INTERNATIONAL MOUNTAIN BICYCLING ASSOCIATION AUSTRALIA

Trail Audit Documentation

Manly Dam (Manly Warringah War Memorial Park)

- Warringah Council

Section 2 - Inset 1: proposed re-route

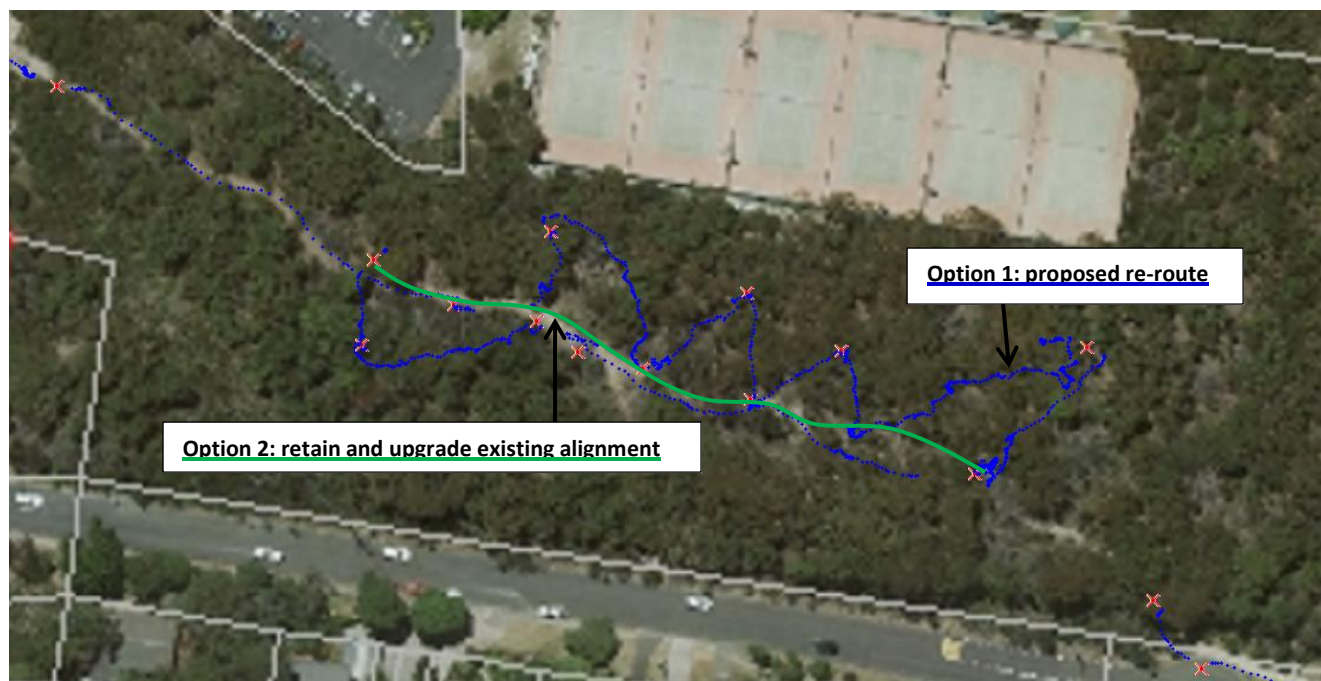
Although the side-slope gradient is modest (approx. 12%) the trail is eroding due to its alignment on the fall-line.

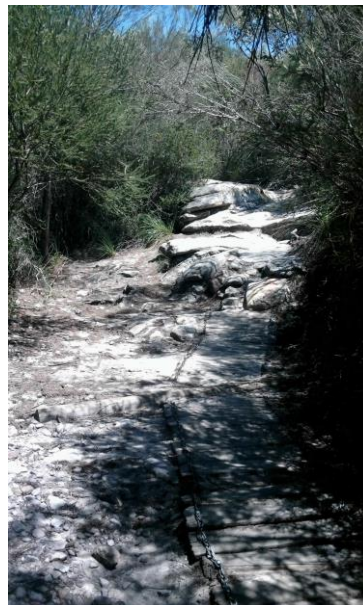
WP1.49 (above) – Entry into the chute is quite technically challenging and thus an effective filter. Signage is required to caution users of the technical challenge ahead, (and highlight the B-line option if it is approved / developed).

WP1.50 (right) – Exit of chute section. The Dutch ladder has been used effectively here to protect from braking impacts on the exit but trail widening has occurred. Again the long term recommendation is to replace all Dutch ladders with stone armouring eventually.

Section 3 - Inset 1: proposed B-line

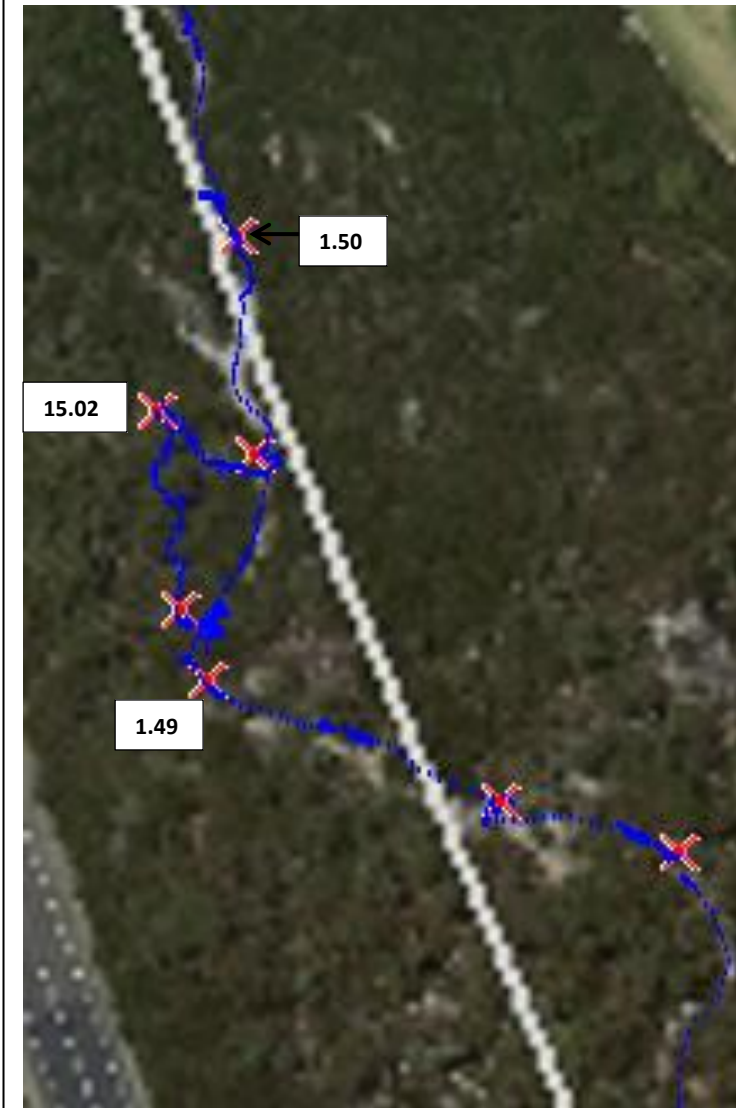
The steep chute is between WP49 & WP50. An alternative alignment has been flagged on a sustainable gradient to provide a blue-square level B-line option around this technical section. Construction of the B-line option would require some stone armouring in the tread to ensure sustainability. Appropriate signage should be installed clearly identifying the technically less difficult and more difficult options.

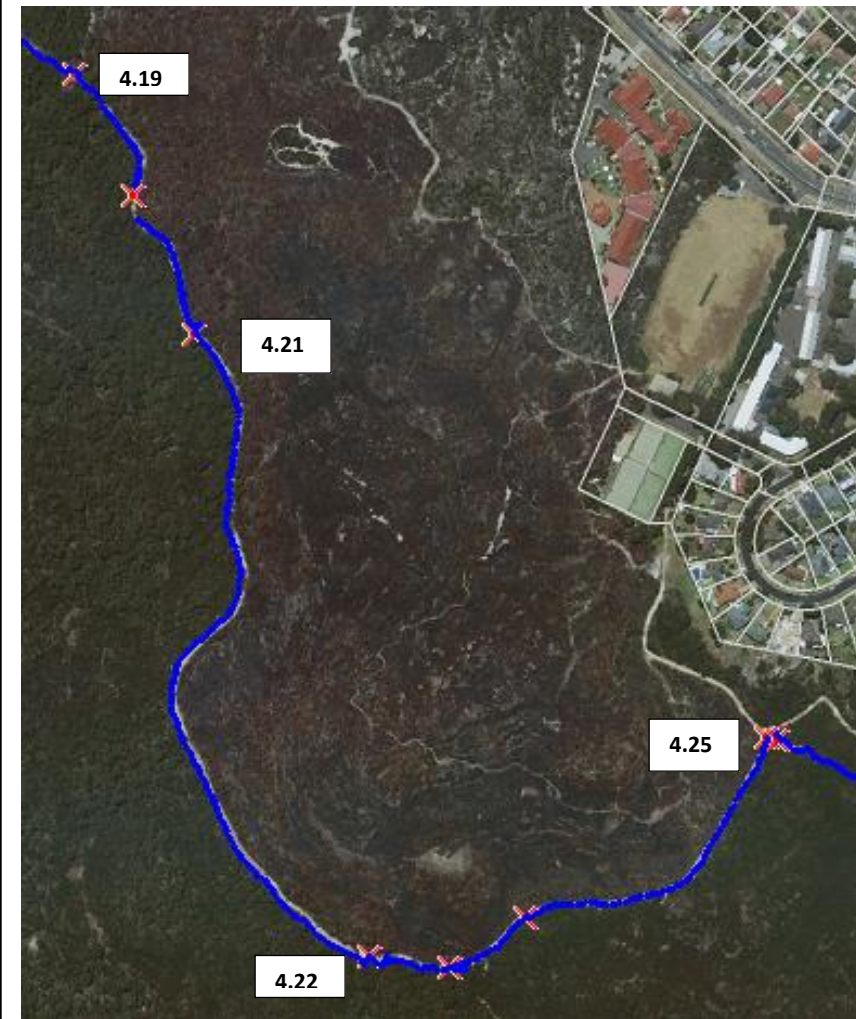
Typical view of Section 6 management track. This photo shows that even on relatively gentle topography, trails without regular drainage features can still easily erode or in this case, become cupped. Fortunately it is quite easy to fix this kind of impact; some resurfacing and installation of drainage features will provide a sound tread for a long time to come.

Entry

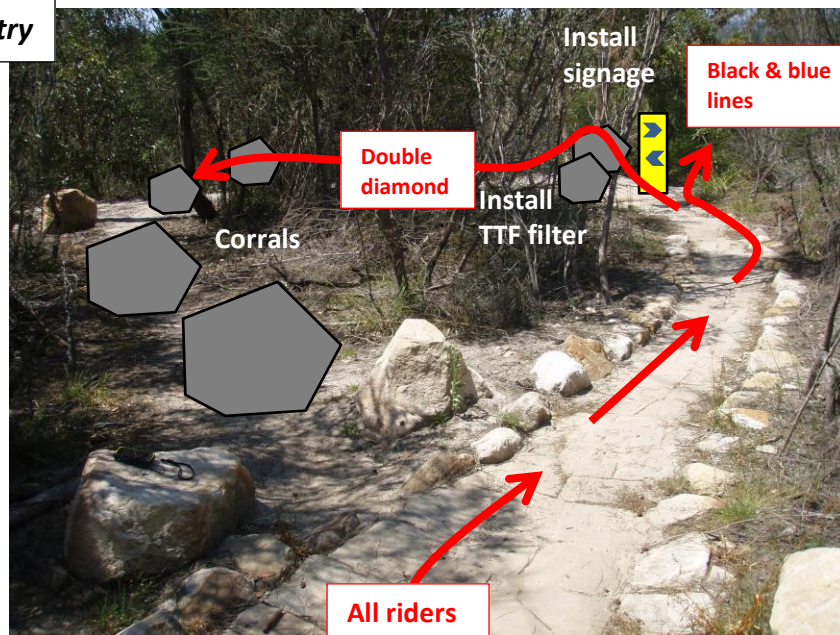
WP4.27 – 'Top of 19th Hole'. The stone armouring on RHS line is excellent. All riders should be directed onto the RHS line. The LHS (straight) line is the more obvious / natural line to ride yet leads directly to the most technically difficult feature. Very large un-movable corral stones should be placed to completely block the LHS ride line. A new junction should be created forcing riders seeking the double-diamond line to consciously choose it by deviating from the main ride line and riding a challenging Technical Trail Feature (TTF) that will act as a trail filter.

Exit

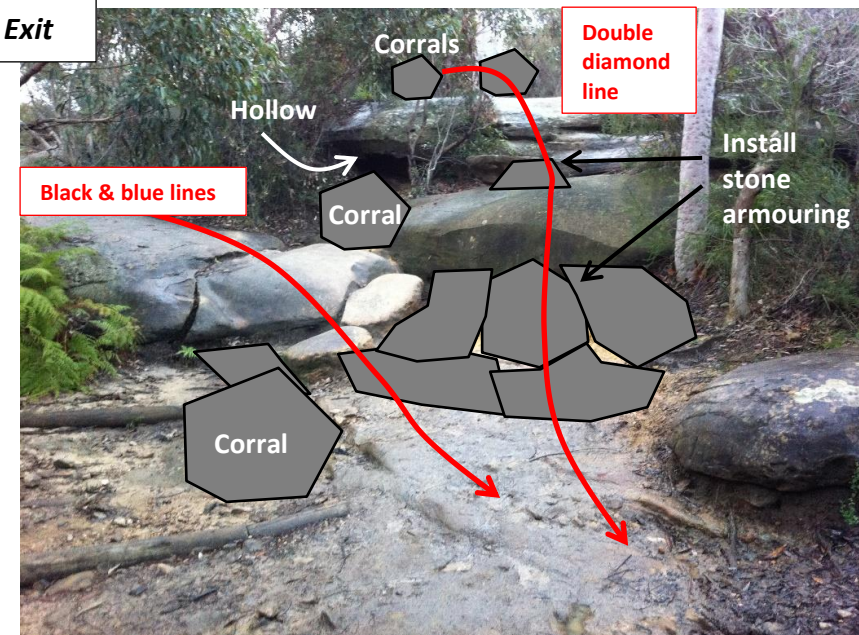
Exit of 19th Hole – Substantial stone armouring is required to improve the transition and protect the impact zone on the exit of all lines. Corrals are also required to consolidate the exit. The entry to the double-diamond line should be better defined with additional corrals.

Black-diamond & Blue-square Lines

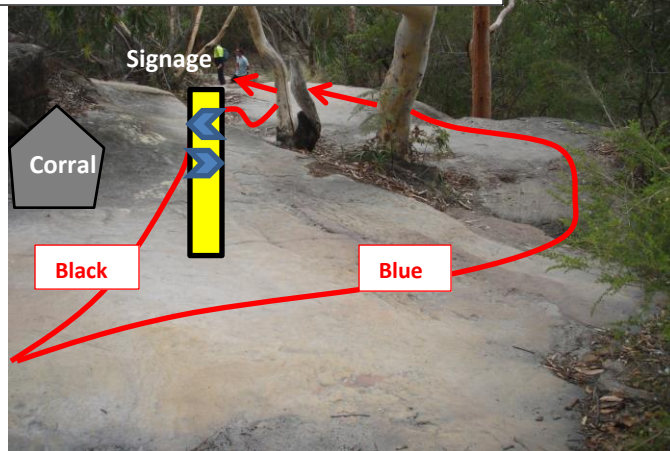
(Left) – View looking down black-diamond and blue-square lines. Signage and corrals should be installed.

Black-diamond line

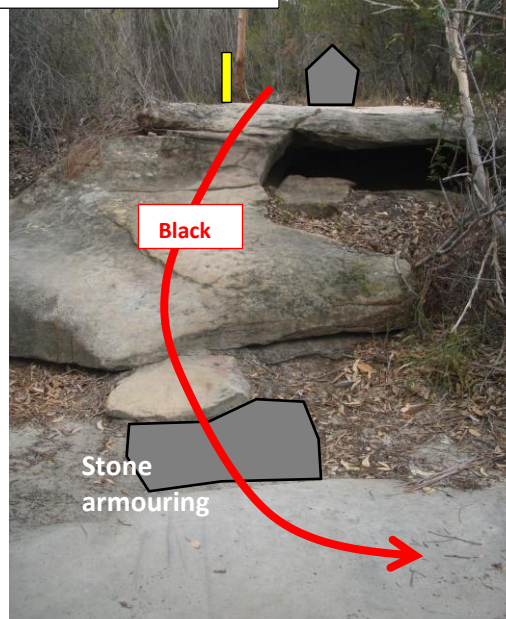
(Left) – View looking up black-diamond line. Some minor stone armouring will enhance this line.

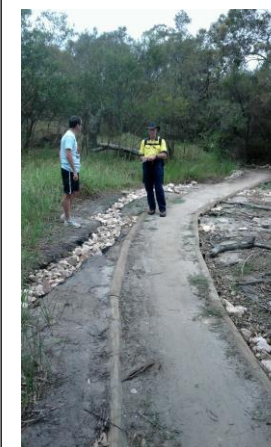
WP6.17 – A well-constructed raised tread section. This technique is very effective. Stone is recommended rather than timber and this feature may need regular maintenance to prevent drain blockages.
